[Change of component]

1. Change to alternative development parts

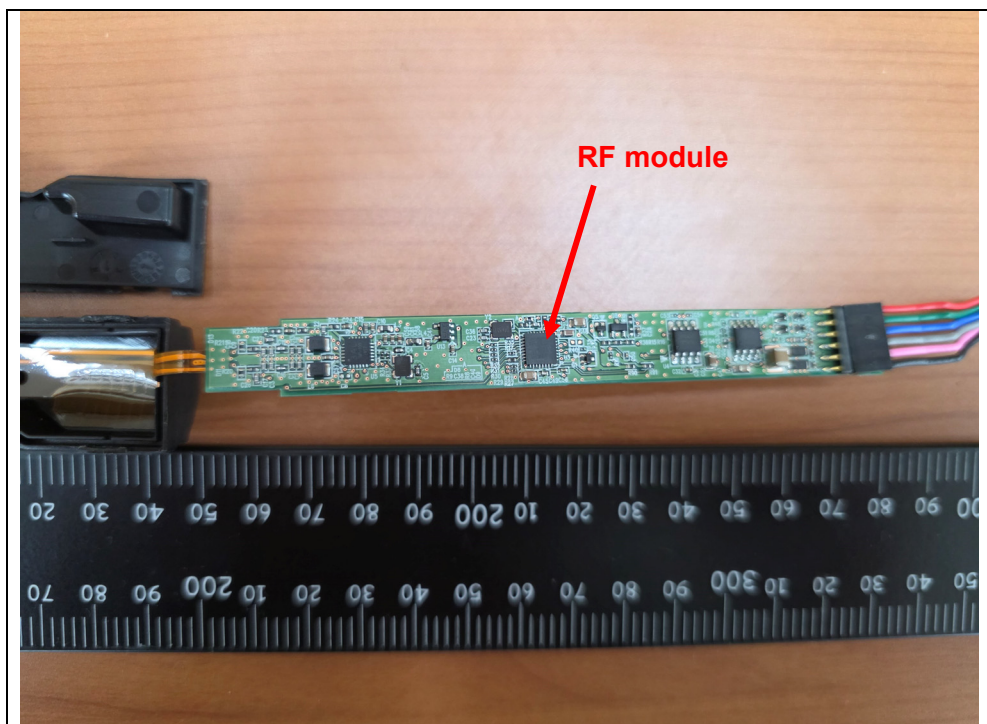
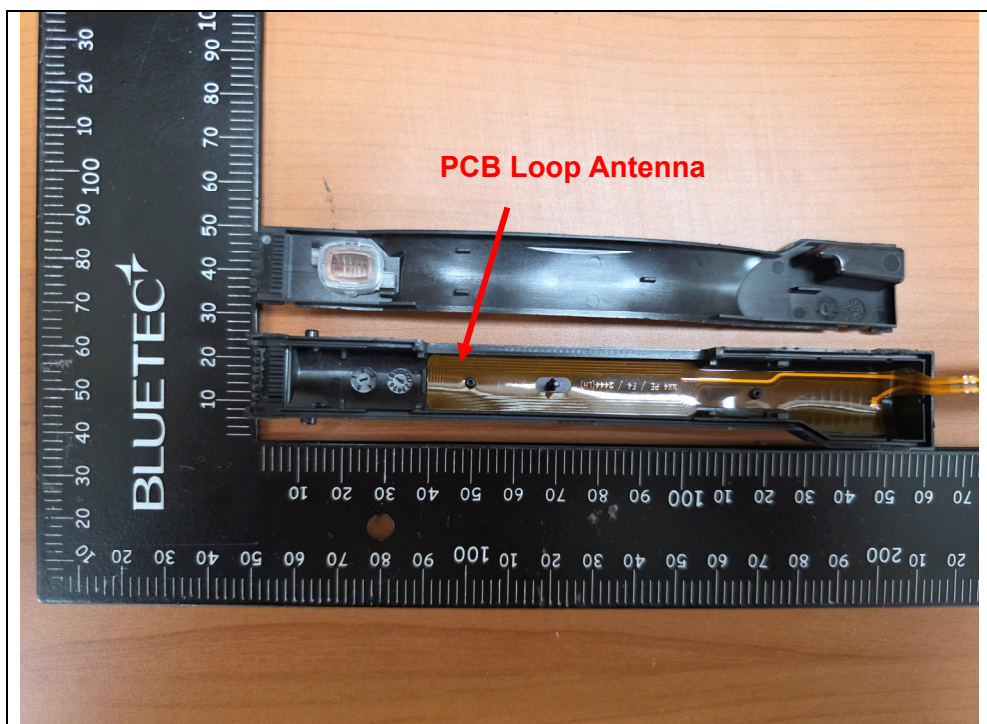
[Original]

[New]

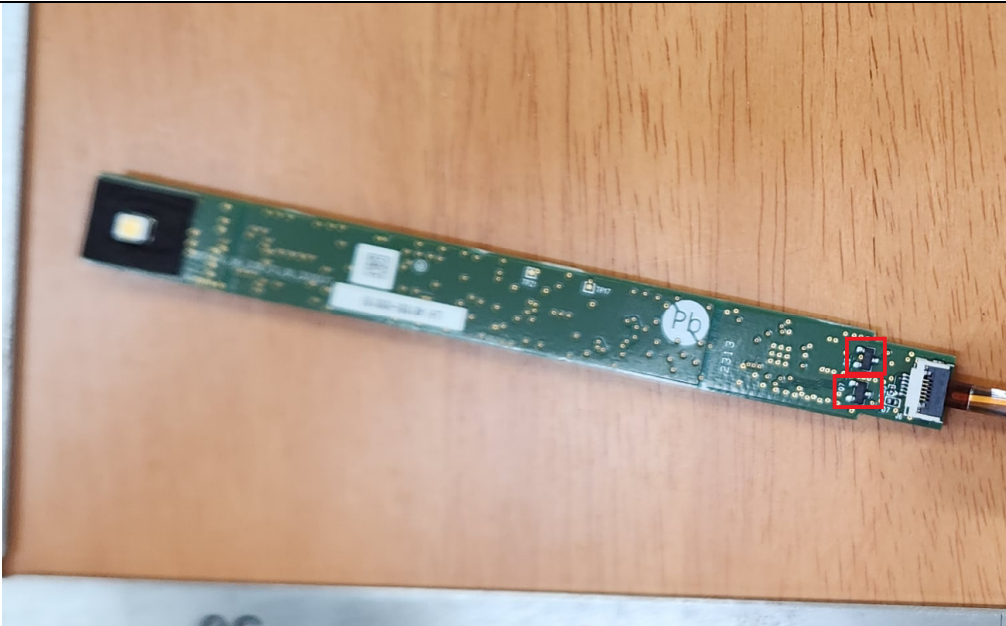
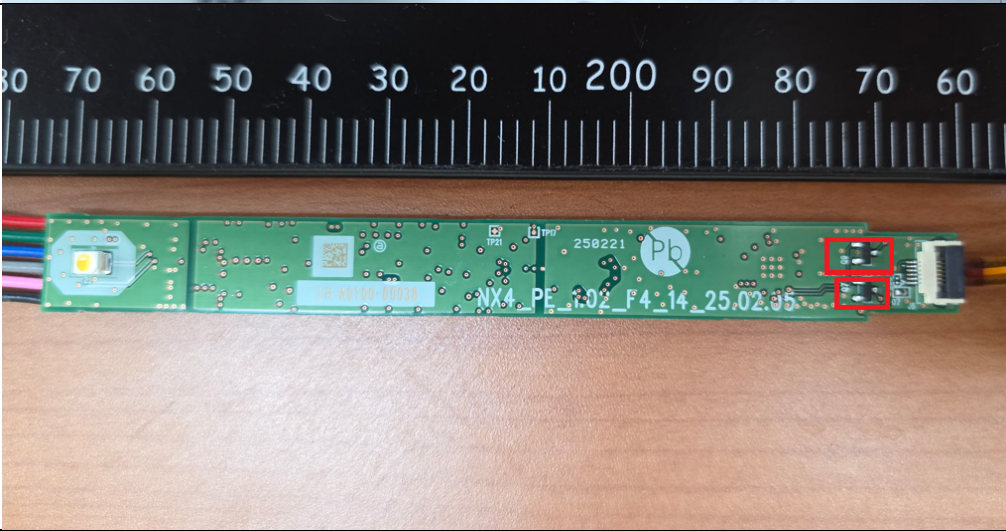
1. J1 = FROM E0903-0001 TO E0903-00006 (Change pinheader company)
D5, D6 = FROM E0305-00033 TO E0305-00042 (Change pinheader company)
2. D4 = FROM E0305-00034 TO E0305-00043
3. U1 = FROM E0009-00064 TO E0009-00087
C7, C60 = OPEN processing
4. Q10, Q11 = FROM E0400-00038 TO E0400-00063
5. U13 = FROM E0009-00074 TO E0009-00088
6. Y1 = FROM E0500-00004 TO E0500-00008
- Changing the Device Value: C4, C5 : FROM 13PF TO 10PF(E0100-00226)
R34 : FROM 681/0603/J/Q TO 152/0603/J/Q(E0200-00632)
(Apply LOAD CAP tuning value due to X-TAL change)
7. L3, L4 = FROM E1203-00013 TO E1203-00001
8. Q5 = FROM E0400-00038 TO E0400-00063
Q8 = FROM E0401-00028 TO E0401-00034
9. Q1 = FROM E0400-00038 TO E0400-00063
C11 (Circuit position shift)
10. C17, C18 FROM 18PF TO 20PF/1% (Changing the Device Value)
C3, C9 FROM 68PF/5% TO 68PF/1% (Changing the Device Value)

2. Reflection of standardized power supply design

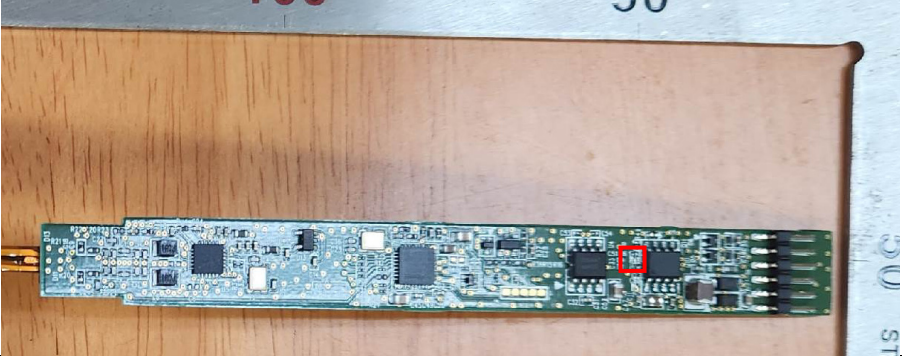
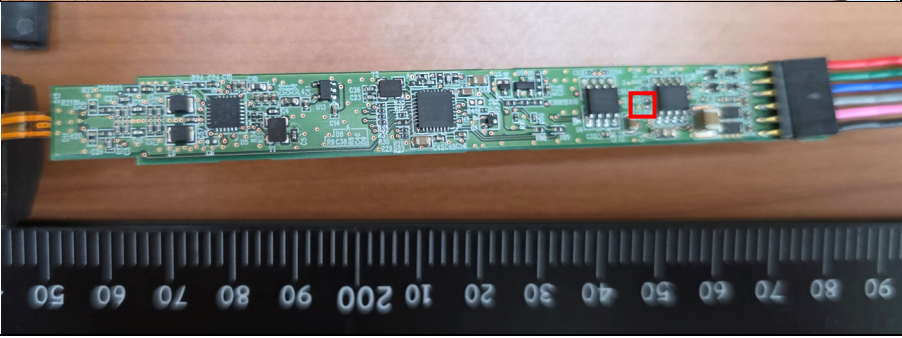
Q7, Q9 = FROM E0401-00030 TO E0401-00037

C37 0.1uF/1608/100V/Q deleted

C62, C63 0.1uF/1005/50V/Q added (E0100-01221)
